Note of meeting

Date: 27/10/15

Manorsfield Road Bus Stop

Figure 1: Approximate location of Manorsfield Road bus stop pole and flag

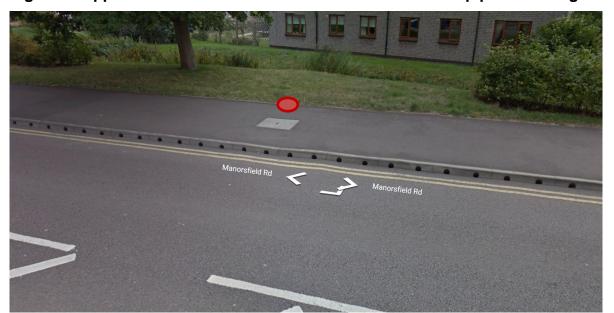
DT: Suggested that the pole and flag should be located at the back of the shared footway/cycle path in the approximate location as identified in figure 1 (see overleaf).

CJ: Noted that the tree (which can be seen on the left of figure 1) ought to be cut back as it would cause a visual obstruction to the flag and is overhanging the path.

Decision: A bus stop will be provided on Manorsfield Road (northbound) at the approximate location shown on figure 1. The flag will bear the stop number 8. Following the various pedestrian safety and traffic obstruction concerns raised, the location of the stop will be monitored by all concerned through observation and periodic checks, rather than formal surveys. The ongoing suitability of this stop location will be reviewed following the first

Action: WP to contact OCC Trees team.
